HISTORIC AND DESIGN REVIEW COMMISSION

October 16, 2024

HDRC CASE NO: 2024-345
ADDRESS: 141 LAVACA ST
LEGAL DESCRIPTION: NCB 13815 BLK 4 LOT 1, 3, & SW IRR 104.5 FT OF 2
ZONING: O-2, H
CITY COUNCIL DIST.: 1
DISTRICT: Lavaca Historic District
APPLICANT: Spencer Solomon/Oxbow Development Group, LLC
OWNER: OXBOW REAL ESTATE LLC
TYPE OF WORK: Construction of three, multi-story, mixed-use structures; deconstruction and reconstruction of a historic structure; site work
APPLICATION RECEIVED: September 27, 2024
60-DAY REVIEW: November 26, 2024
CASE MANAGER: Edward Hall
REQUEST:

A5.11

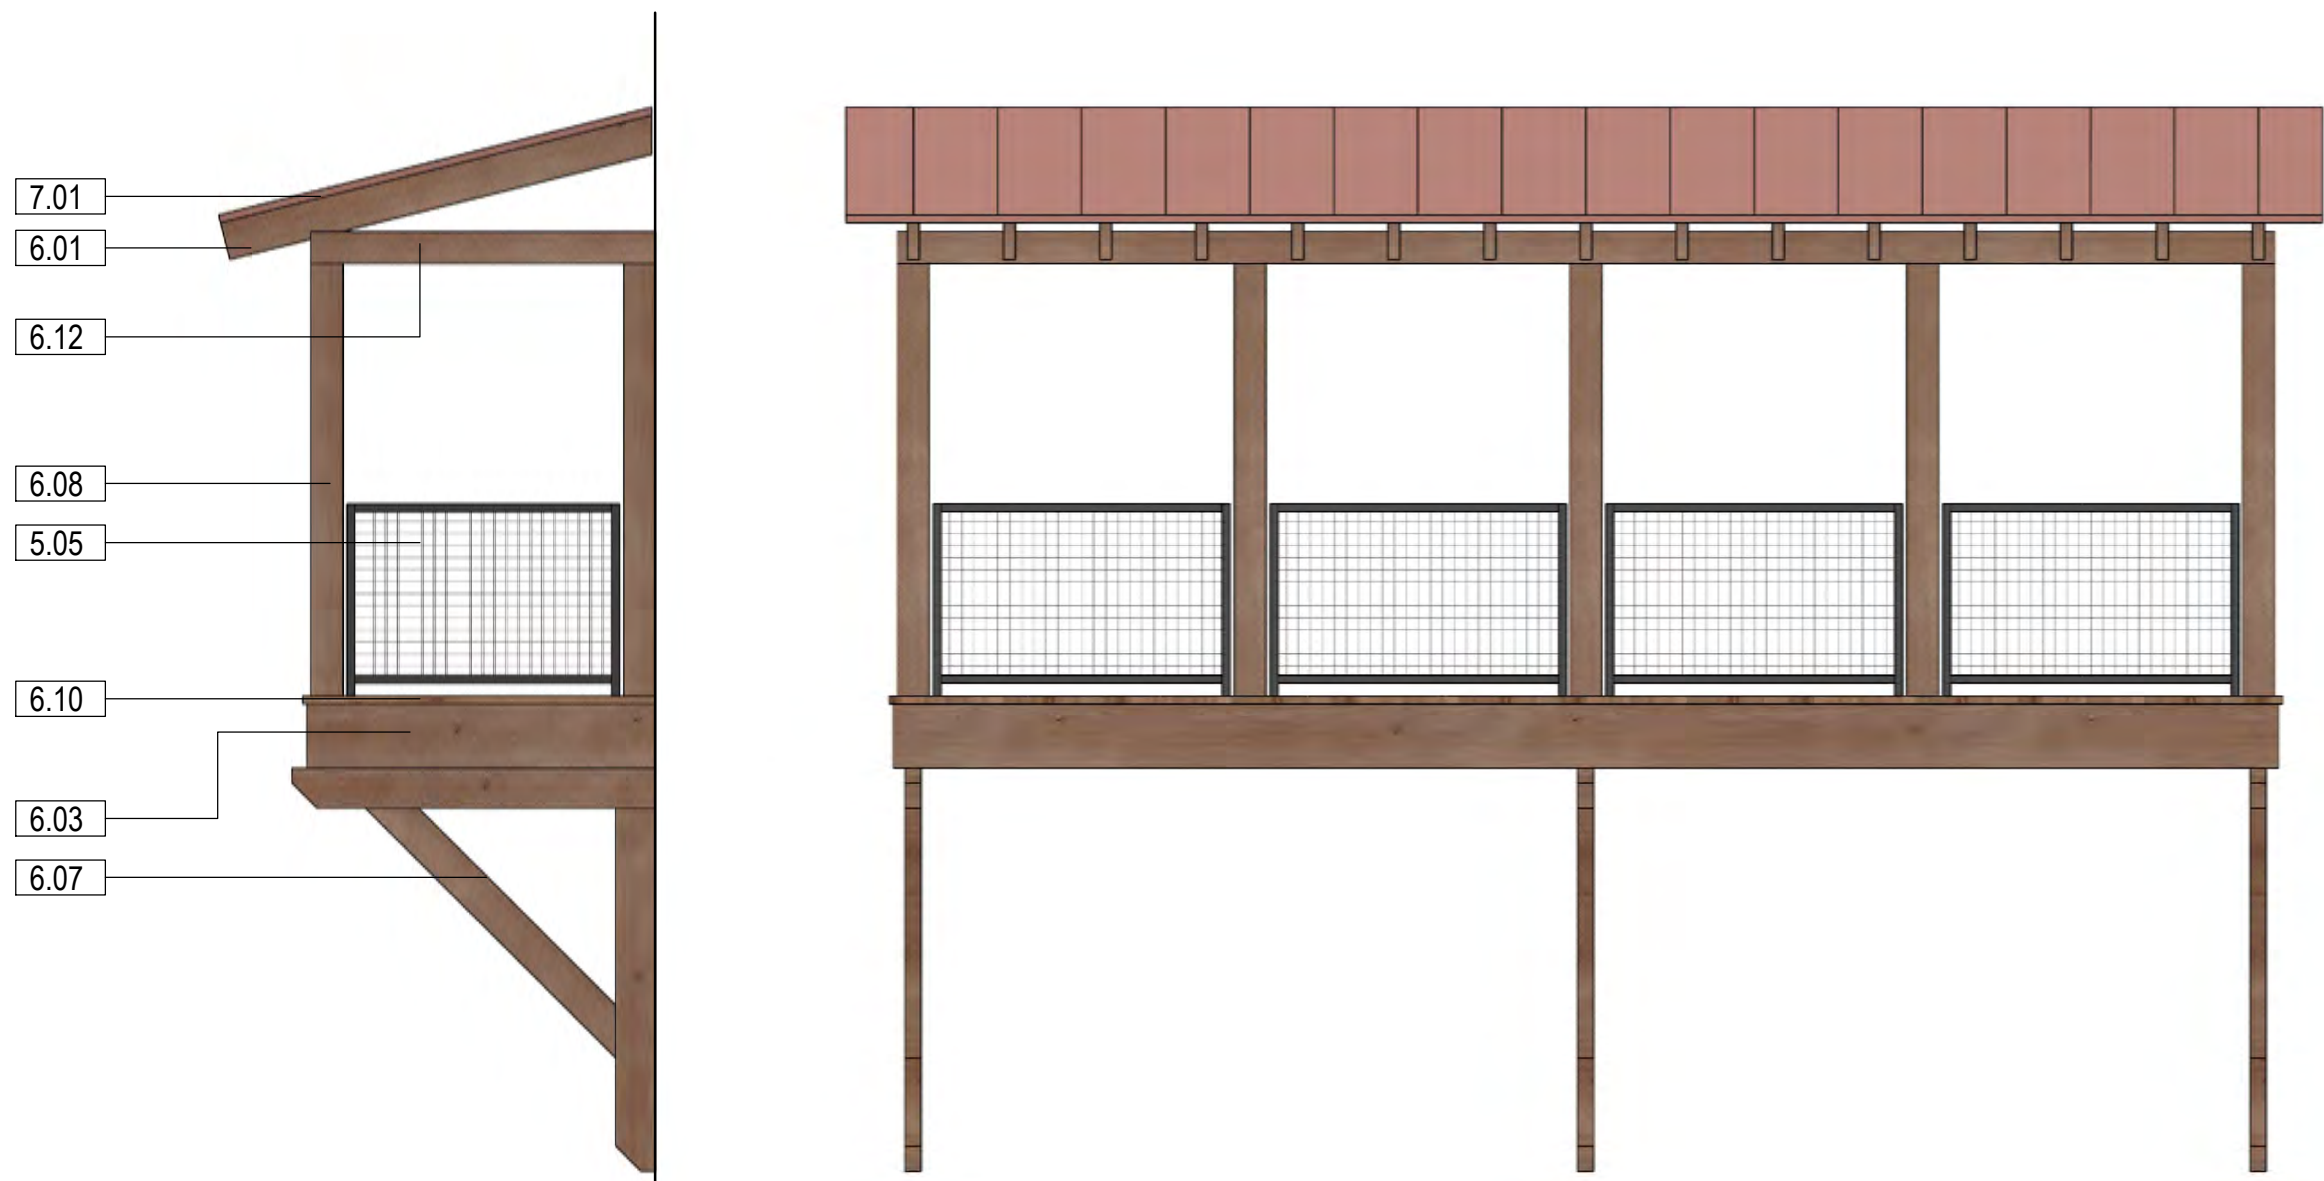
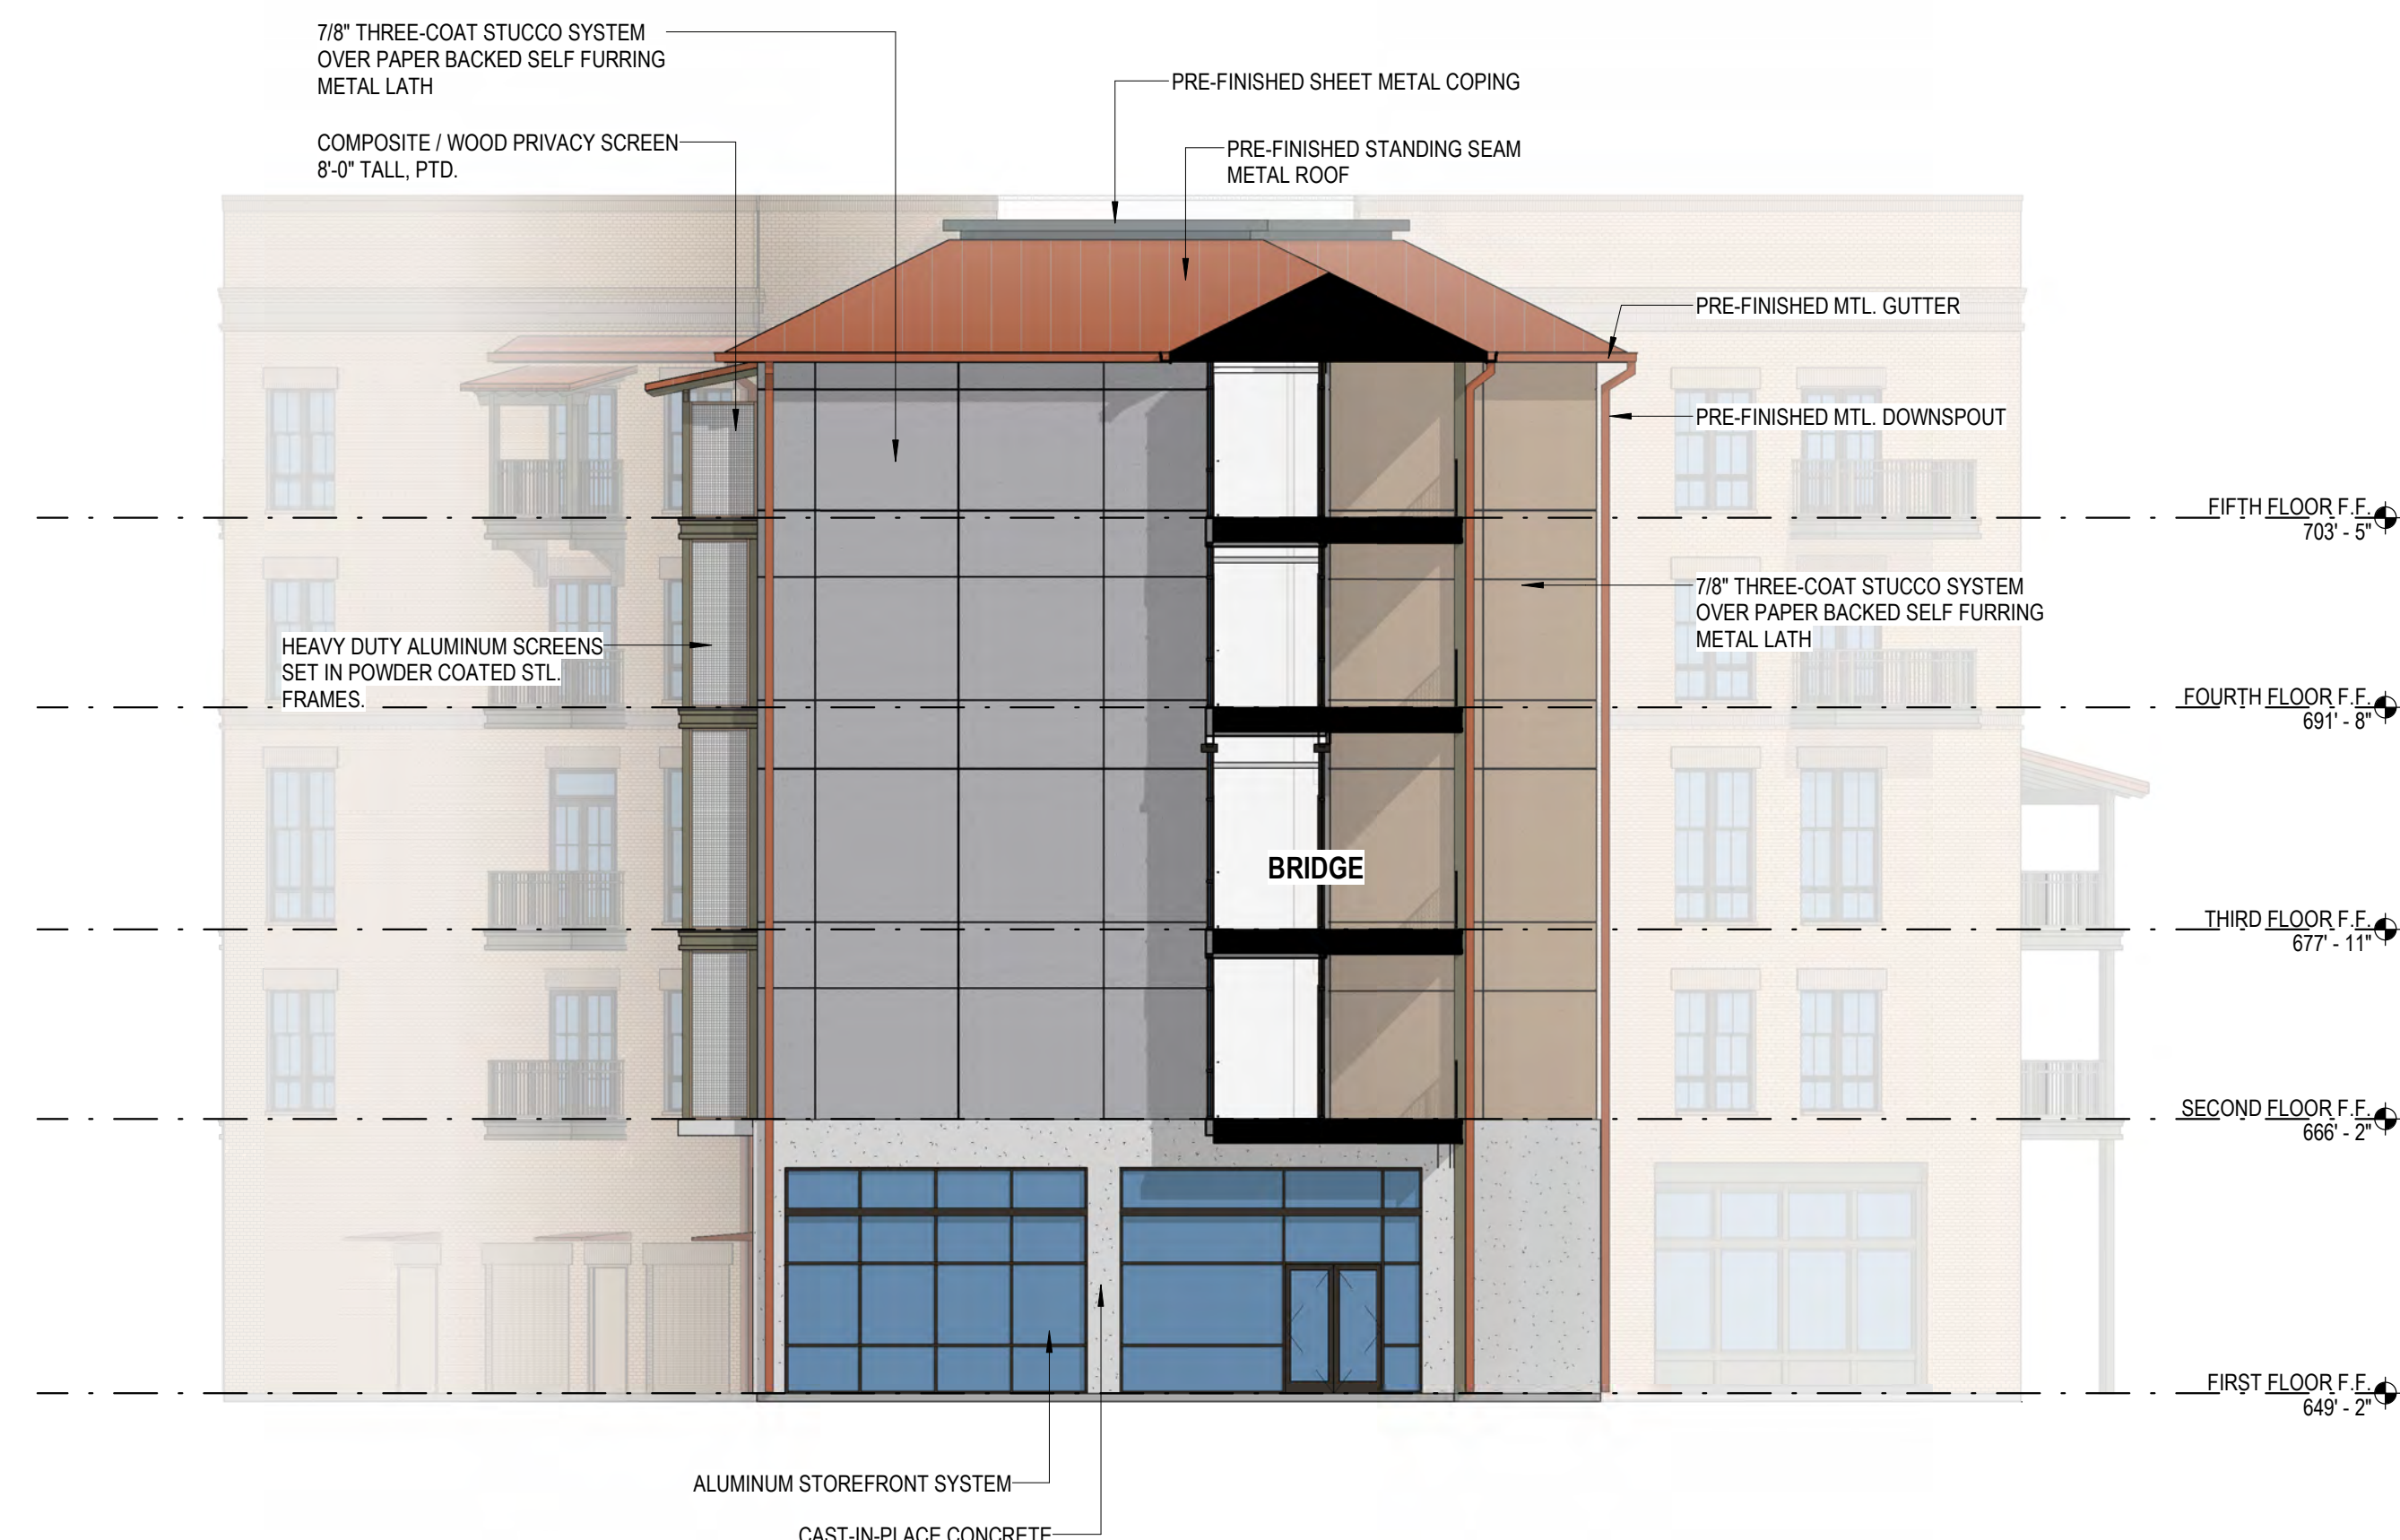
- 3a. The applicant has proposed to construct a 5-story, mixed-use structure to be located at the southern portion of the site and border Lavaca Street to the south and S Alamo to the west. The floor plans for this structure are found on sheet G0.20. The elevations for this structure are found on sheets A5.11, A5.12, and A5.13.

- 3b. SETBACKS & ORIENTATION – According to the Guidelines for New Construction 8.B.i and ii, the front facades of new buildings are to align with front facades of adjacent buildings where a consistent setback has been established along the street frontage. Additionally, the orientation of new construction should be consistent with the historic examples found on the block. The applicant has sited the proposed new construction to feature frontage to both S Alamo Street and Lavaca Street, to be located adjacent to the right of way with minimal setbacks and be oriented to front the right of way. Generally, staff finds the proposed setbacks and orientation to be appropriate. The applicant is responsible for obtaining any variances or additional Zoning approvals for the proposed setbacks.

- 3c. ENTRANCES – According the Guidelines for New Construction 1.B.i. primary building entrances should be orientated towards the primary street. The applicant's proposed entrance orientation is consistent with the Guidelines, as entrances are oriented towards both S Alamo Street and Lavaca Street.

- 3e. **BUILDING HEIGHT, MASS & SCALE** – Per the Guidelines for New Construction 8.C.iii., new construction should be designed so that its height and overall scale are consistent with historic buildings in the established context area. In residential districts, the overall height of new construction should not exceed the height of adjacent or nearby historic buildings by more than 50% when measured from similar elevation points such as the ground plane and the highest ridge line of the roof regardless of roof pitch or form. Buildings that exceed the height of immediately adjacent historic buildings by any amount should utilize half story massing elements, height transition elements, or roof forms that reduce visual prominence. The immediate vicinity features 2-story commercial structures, 2-story residential structures and 1-story residential structures. The applicant has proposed for the structure to feature an overall height of approximately 72' feet in height. Facing residential portions of Lavaca Street, the applicant has proposed an increased setback for the 5-story massing and to construct two, single-story masses formed as residential structures to provide a height transition to the existing, one-story structures across Lavaca Street. These two elements are referred to as casitas in the construction documents. Generally, staff finds the proposed massing to be appropriate as this site is a transition site and is located adjacent to Downtown Zoning and is in the vicinity of similarly massed structures. The applicant is responsible for obtaining all zoning approvals for the proposed setbacks.

- 3h. **MATERIALS** – The applicant has proposed materials that include brick, standing seam metal roofs, wood and aluminum framed storefront systems, wood columns and balcony elements, cast-in-place concrete, vinyl windows, stucco and steel doors. Generally, staff finds the proposed materials to be appropriate and consistent with those found historically on commercial structures within the district.

- 3i. **WINDOW MATERIALS** – The applicant has proposed vinyl windows with divided lites. Staff finds that all windows should adhere to the adopted standards for windows in new construction. A vinyl window product may be appropriate provided it is consistent with the standards. Window product details should be submitted for review and approval. Faux divided lites should not be proposed.

A5.21

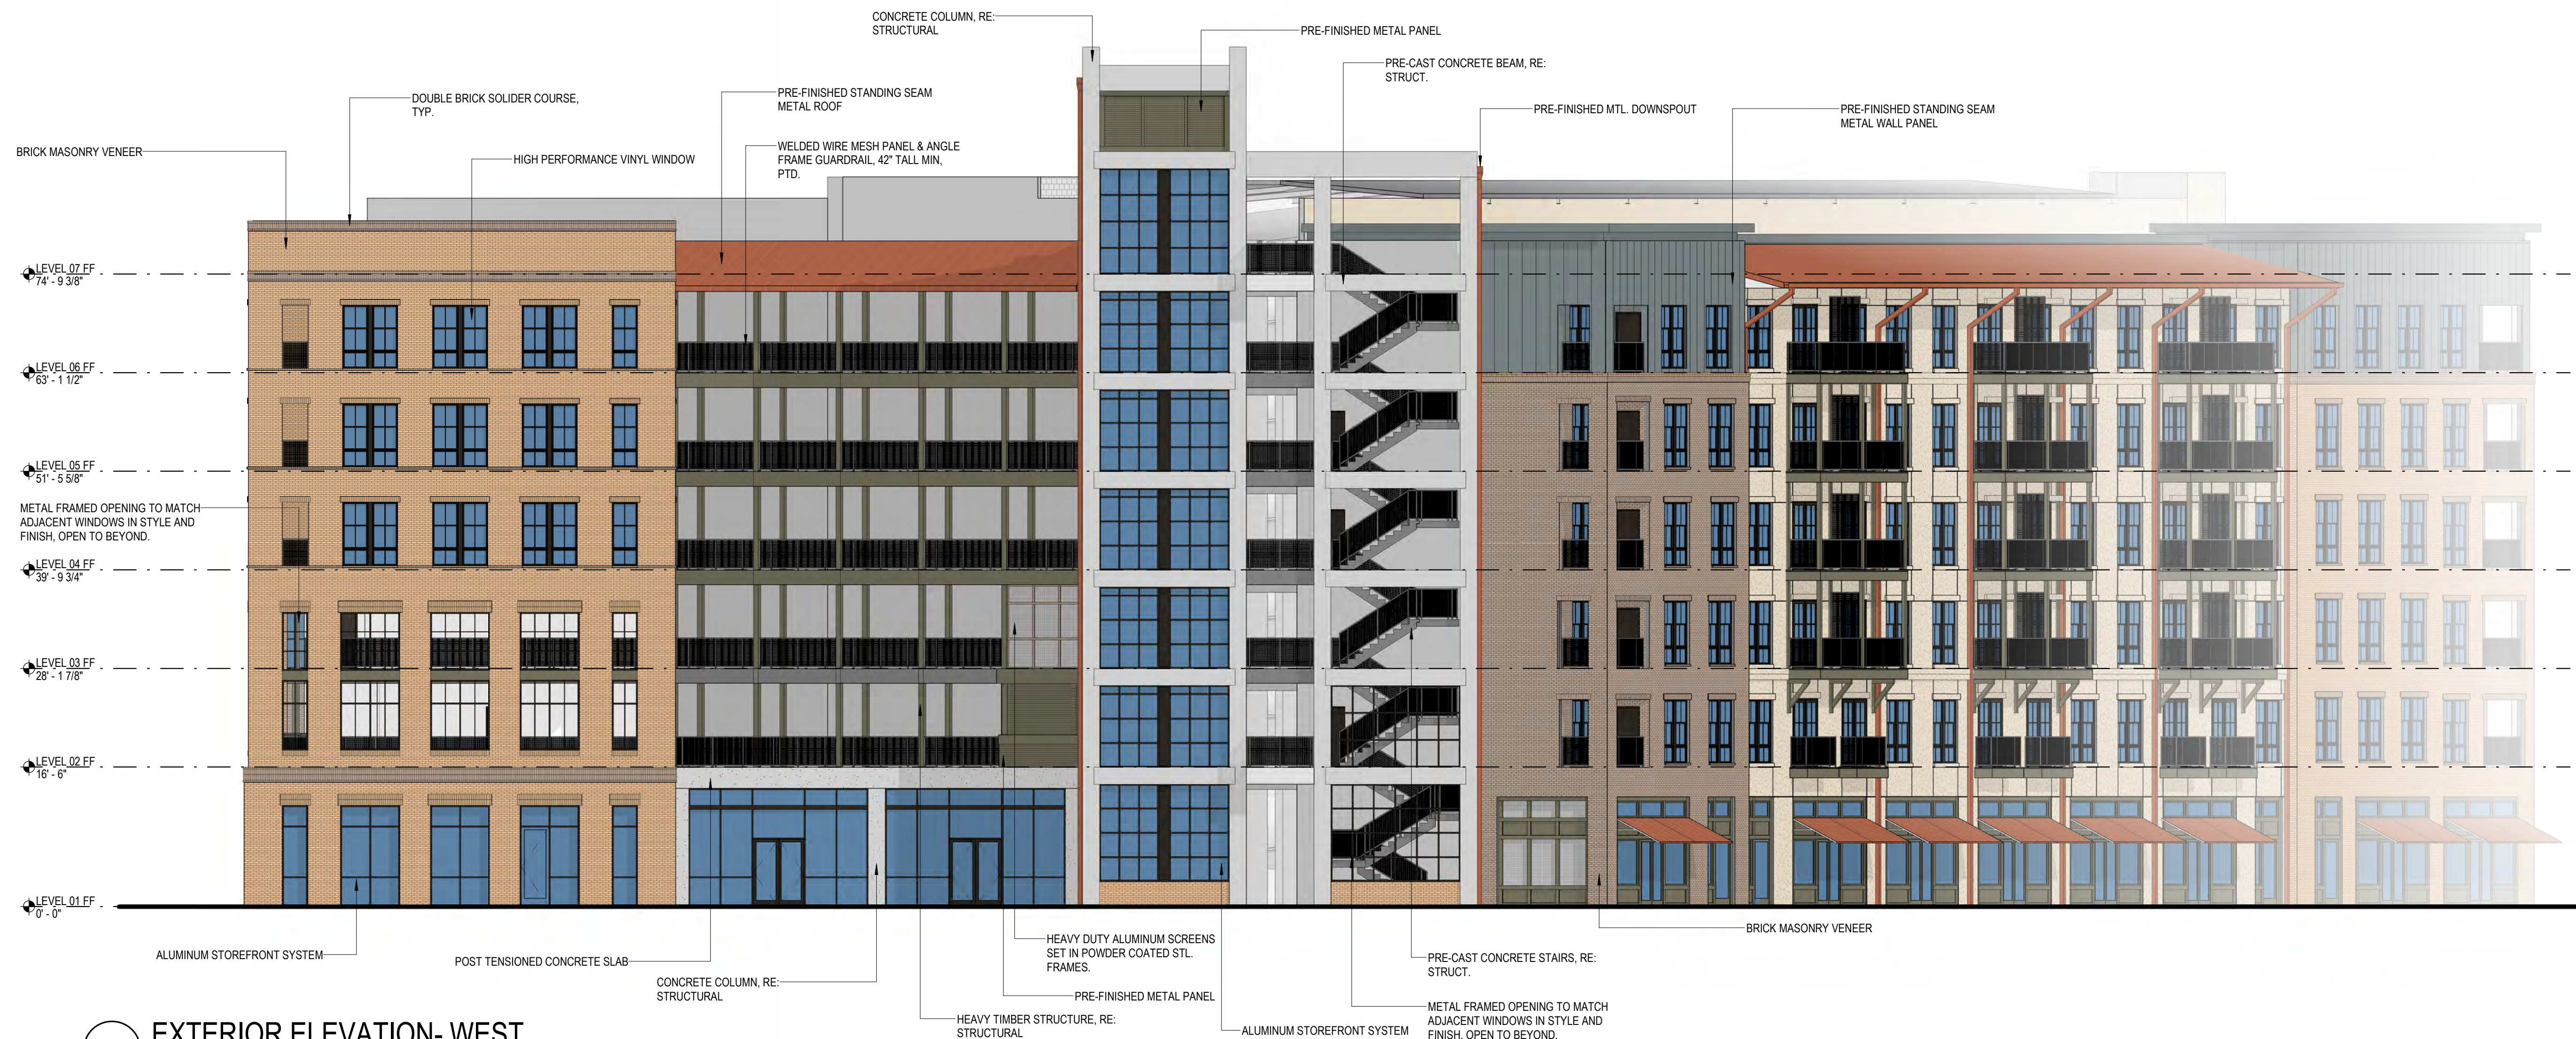
- 5a. The applicant has proposed to construct a 6-story, mixed-use structure to be located at the eastern portion of the site to feature a wrapped parking structure. The floor plans for this structure are found on sheet G0.21. The elevations for this structure are found on sheets A5.21 and A5.22.

- 5k. ARCHITECTURAL DETAILS – Generally, staff finds the proposed architectural details to be appropriate; however, as noted in finding 5j, staff finds that all structure parking elements should be screened, whether through landscaping elements or building materials, specifically as viewed from the right of way, to the fullest extent possible.
- 5l. MECHANICAL EQUIPMENT – Per the Guidelines for New Construction 6 A and B., all mechanical equipment should be screened from view at the public right of way. The applicant is responsible for screening all mechanical equipment where it cannot be viewed from the public right of way.
